IDAPA 39 – IDAHO TRANSPORTATION DEPARTMENT

39.03.41 – Rules Governing Traffic Control Devices

004. INCORPORATION BY REFERENCE.

Figure 2B-33. Slow And Move Over For Stopped Vehicles With Flashing Lights Sign

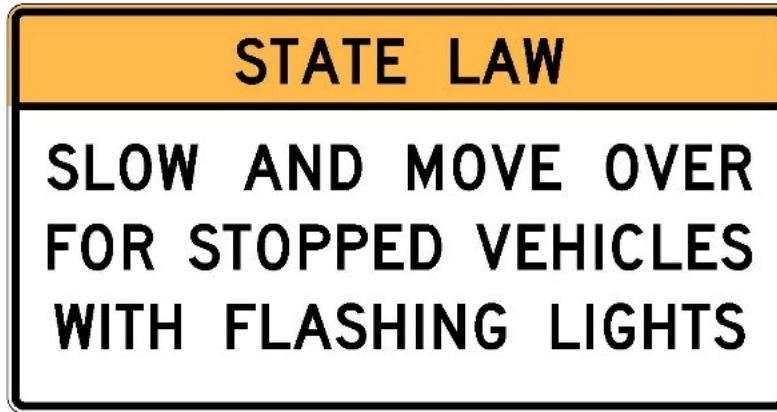
07. Section 2B.69, SLOW AND MOVE OVER FOR STOPPED VEHICLES WITH FLASHING LIGHTS (R16-101) sign. On page 102, add the following section:

Option:
02 The SLOW AND MOVE OVER FOR STOPPED VEHICLES WITH FLASHING LIGHTS (R16-101) sign (see Figure 2B-33) may be used to inform road users of the state law on multi-lane highways.

Standard:
03 **If used, the SLOW AND MOVE OVER FOR STOPPED VEHICLES WITH FLASHING LIGHTS sign shall only be used on highways with two or more lanes in each direction.**

Option:
04 The legend STATE LAW may be displayed at the top of the SLOW AND MOVE OVER FOR STOPPED VEHICLES WITH FLASHING LIGHTS sign.

Standard:
05 **If used, the legend STATE LAW shall be black with a black border on a yellow background.**

08. Figure 2B-33. Slow and Move Over for Stopped Vehicles with Flashing Lights Sign. On page 102, add the following figure:

Figure 2B-34. Chains Required On Non-Exempt Commercial Vehicles Sign

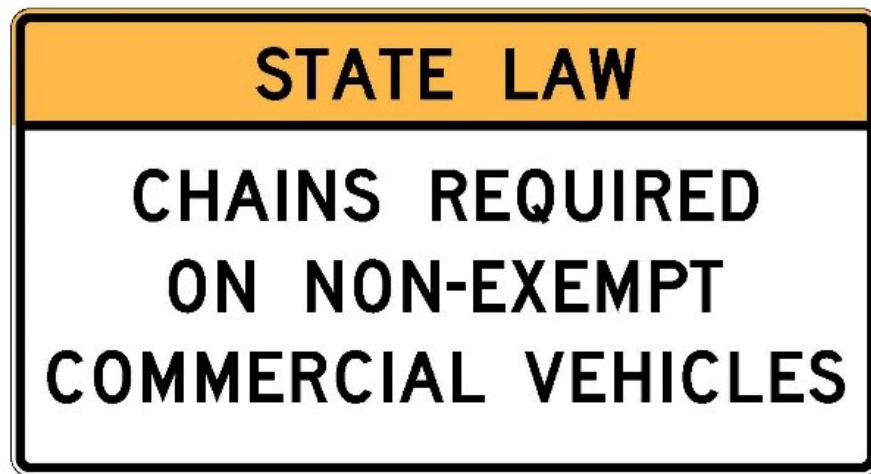
09. Section 2B.70, CHAINS REQUIRED ON NON-EXEMPT COMMERCIAL VEHICLES (R16-201) sign. On page 102, add the following section:

<p>Standard:</p> <p>01 CHAINS REQUIRED ON NON-EXEMPT COMMERCIAL VEHICLES (R16-201) signs (see Figure 2B-34) shall be installed when mountain passes are determined to be unsafe by the Idaho Transportation Department. If used, two or more CHAINS REQUIRED ON NON-EXEMPT COMMERCIAL VEHICLES signs shall be installed in advance of an area that has been provided for drivers to pull off of the highway to install chains on their tires (see Section 2I.07).</p> <p>Support:</p> <p>02 Commercial vehicles required to use chains include:</p> <ul style="list-style-type: none">• Vehicles with a combined weight in excess of 26,000 pounds including a trailer with a rating of more than 10,000 pounds• Vehicles with weight in excess of 26,000 pounds <p>03 Commercial vehicles exempt from chain requirements include:</p> <ul style="list-style-type: none">• Idaho Transportation Department vehicles used in the maintenance of the highway• School busses or other vehicles used to transport school children and teachers• Vehicles used by farmers to transport agricultural products, supplies, or farm equipment• Mail carrier vehicles• Motor carriers transporting forest products or chips• Motor carriers transporting mining products including sand, gravel, and aggregates, but not petroleum products• Tow trucks <p>Standard:</p> <p>04 The CHAINS REQUIRED ON NON-EXEMPT COMMERCIAL VEHICLES signs shall be removed or covered when the condition no longer applies.</p> <p>05 The CHAINS REQUIRED ON NON-EXEMPT COMMERCIAL VEHICLES sign shall have a black legend and border on a white background.</p>

Option:
 06 The legend STATE LAW may be displayed at the top of the CHAINS REQUIRED ON NON-EXEMPT COMMERCIAL VEHICLES sign.
Standard:
 07 If used, the legend STATE LAW shall be black with a black border on a yellow background.

10. **Figure 2B-34. Chains Required on Non-Exempt Commercial Vehicles Sign.** On page 102, add the following figure:
